## HISTORIC RESOURCES PRESERVATION BOARD REPORT

**HRPB Project Number 24-01500005:** A request for a variance to allow 43.5 linear feet of up to 7.5-foot high fencing along the south side property line at 1209 North Lakeside Drive. The subject property is a non-contributing resource within the Northeast Lucerne Historic District and is located in the Single Family Residential (SFR) zoning district. The future land use designation is Single Family Residential (SFR).

**Meeting Date:** July 10, 2024

Subject fencing at 1209 North Lakeside Drive, ranging from 7-7.5 feet tall (marked in red)

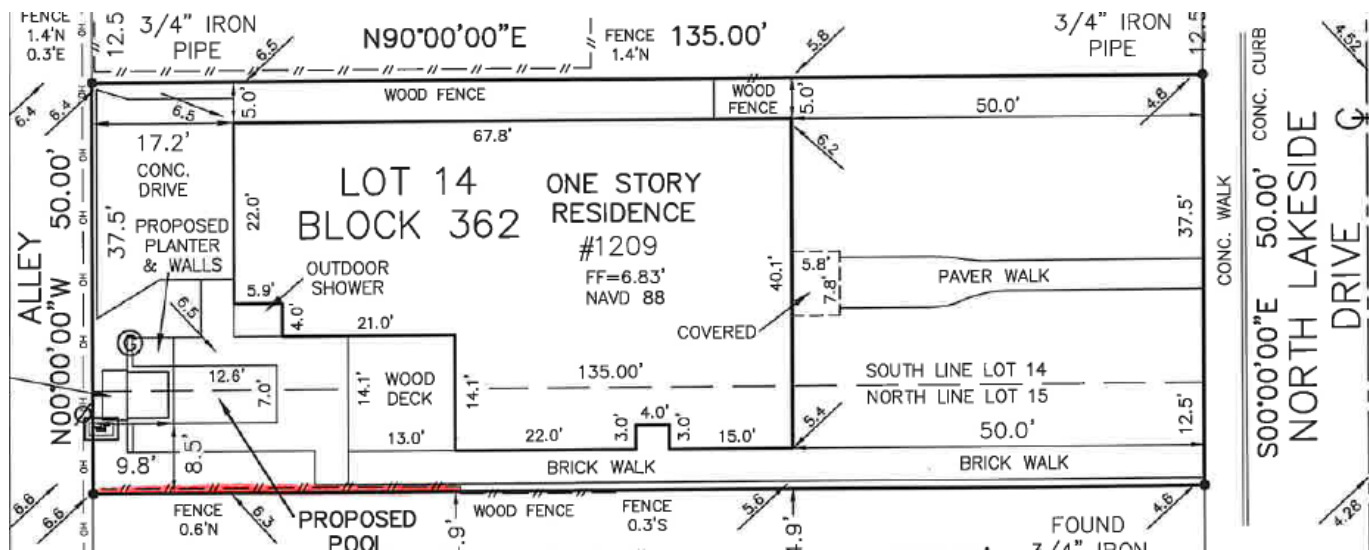
**Analysis:** The fencing on the south side property line at 1209 North Lakeside Drive conflicts with the requirements in the City's Land Development Regulations, specifically the limitations for maximum fence height along side property lines.

Per LDR Section 23.4-4(d)(1)(C), the maximum height of fences or walls on the side property line is six (6) feet. The applicants are proposing about 43.5 linear feet of fencing on the south side property line that ranges from 7 to 7.5 feet in height (see survey image below).

**Analysis:** 1209 North Lakeside Drive is a 50' x 135' parcel; this is the most common lot size throughout Lake Worth Beach. Single-family homes in the surrounding neighborhood and throughout the City are all required to comply with requirements for maximum fence height along their side property lines. Furthermore, the requested variance is the result of unpermitted work done by the applicants. However, the applicants contend that their property has special circumstances due to the location and height of their neighbor’s home, which is a two-story structure situated approximately 1.5 feet from their shared property line. As the circumstances of 1209 North Lakeside Drive apply generally to nearby lands and buildings and the variance request is the result of actions of the applicants, the requested variance does not meet the intent of this criterion. **Does not meet the criterion.**

**Analysis:** The property has accommodated a single-family use for over 40 years. Strict application of the LDRs would require fencing along the side property line to have a maximum height of six feet as measured from the average height of the natural grade on either side of the fence; this configuration would not deprive the applicants of reasonable use of the land as a single-family residence. **Does not meet the criterion.**

**Analysis:** As established above, the proposed variance is not required for reasonable use of the land. While a code-compliant six-foot-tall fence would provide slightly less privacy from the neighboring house, fencing that meets the code would still provide the property owners with privacy for their backyard and would visibility of their neighbors' utility meters, which is a concern expressed in the applicants' justification statement. **Does not meet the criterion.**

**Analysis:** In 2013, the City's new Land Development Regulations were adopted through Ordinance 2013-34. The new LDRs included fence height regulations for front yards, side property lines, and rear property lines. The granting of the variance would be contrary to the intent of the fence regulations. However, the granting of the fence height variance will likely not be unduly injurious to contiguous property, as owners of the adjacent property (1205 North Lakeside Drive) have provided a letter of support for the requested variance. **Does not meet criterion.**

Variance requests are required to be reviewed for consistency with the criteria set forth in LDR Section 23.2-26(b), including the requirement that a hardship be established related to the circumstances of the property. As the circumstances of the subject lot are typical, a hardship was not established. Further, the applicant has not established by competent and substantial evidence that the proposed variance is consistent with the required review criteria, including that the strict application of the LDRs would deprive the property owner of reasonable use of the land. Therefore, staff is recommending that the HRPB not approve the proposed variance based on the data and analysis in this report.
